Re: Oconee Nuclear Station
Docket Nos. 50-269, -270, and -287

INSTRUCTION SHEET
FOR INSERTION OF REVISION 1 TO
ANALYSIS OF EFFECTS RESULTING FROM POSTULATED PIPING BREAKS
OUTSIDE CONTAINMENT FOR OCONEE NUCLEAR STATION
UNITS 1, 2, AND 3

DOCKET NOS. 50-269, -270, AND -287
MDS REPORT NO. OS-73.2

AUXILIARY FEEDWATER SYSTEM
 (INCLUDES BYPASSES AROUND POSTULATE PIPE BREAK AREAS)
 FIGURE 4.2-2 Rev. 1-7-16-73

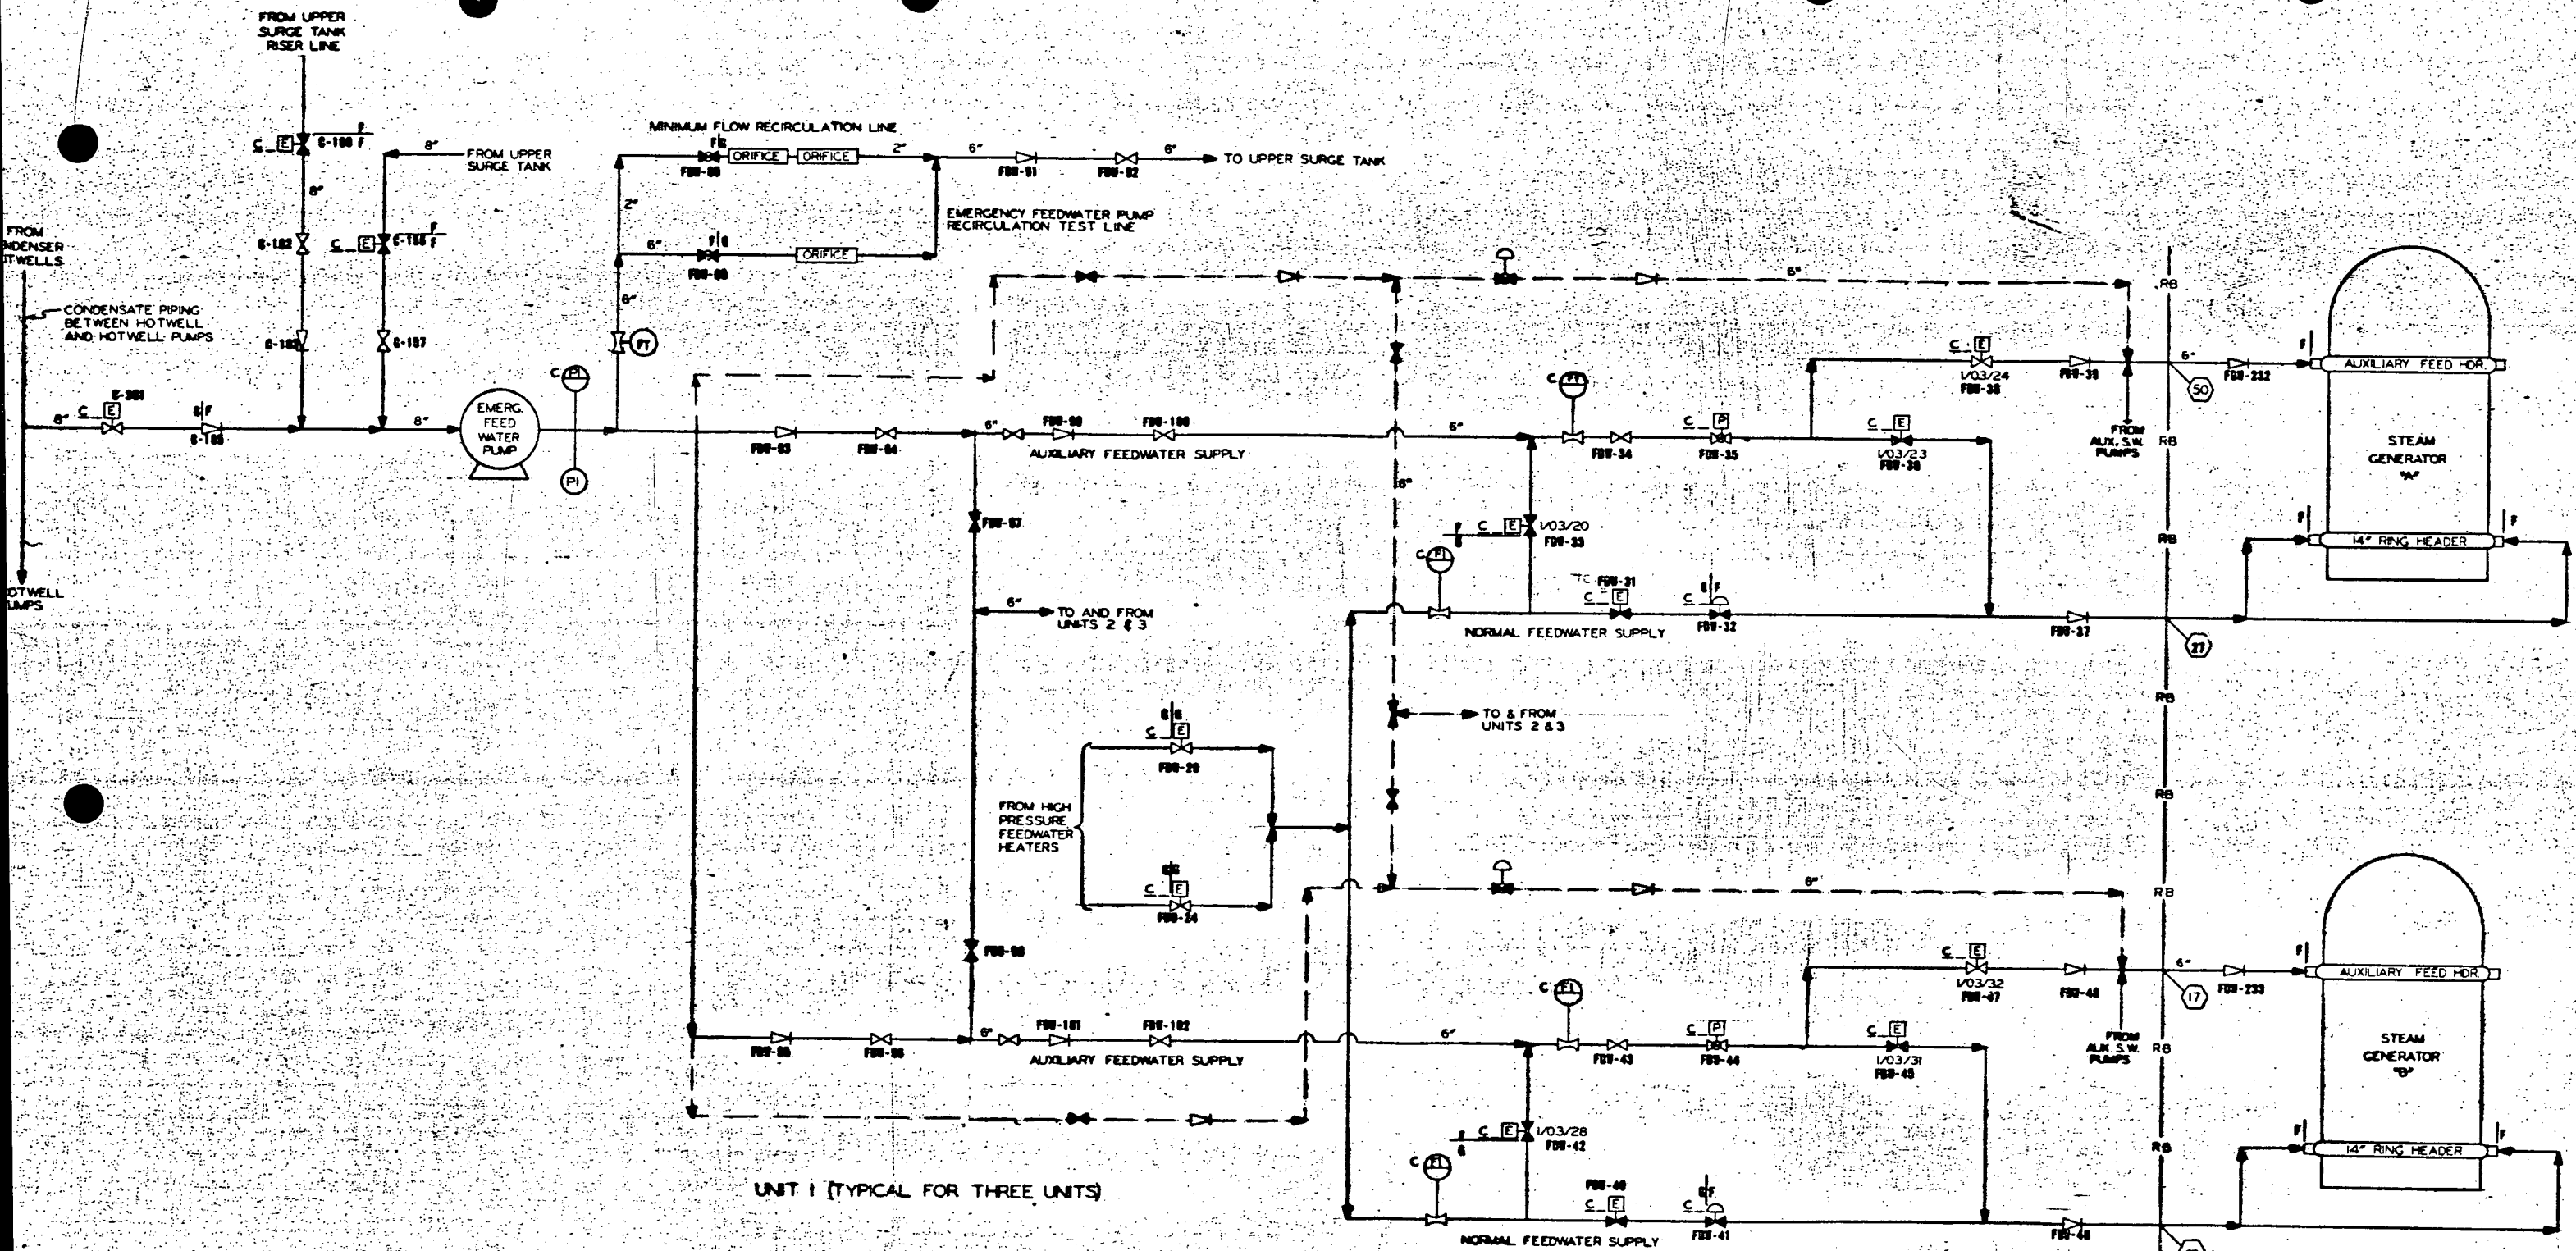
3. All terminal ends and any of consequence	Install Emerg. FDW Bypass lines around postulated pipe break area for both Stm Generators	6 months	See Fig. 4.2-2
Main Feedwater, 03

4.b. FDW Pump Discharge thru HP FDW Htrs. to Turb. Bldg. Wall - any of consequence	Install Emerg. FDW Bypass lines around postulated rupture area for both steam generators	6 months	See Fig. 4.2-2

7. All terminal ends and any of consequence	Install Emerg. FDW Bypass line from Unit 2 around postulated rupture area tying into bypass lines described in 3 and 4.b. above.	6 months	See Fig. 4.2-2

Rev. 1: - - Indicates bypass piping added around postulated pipe break areas.
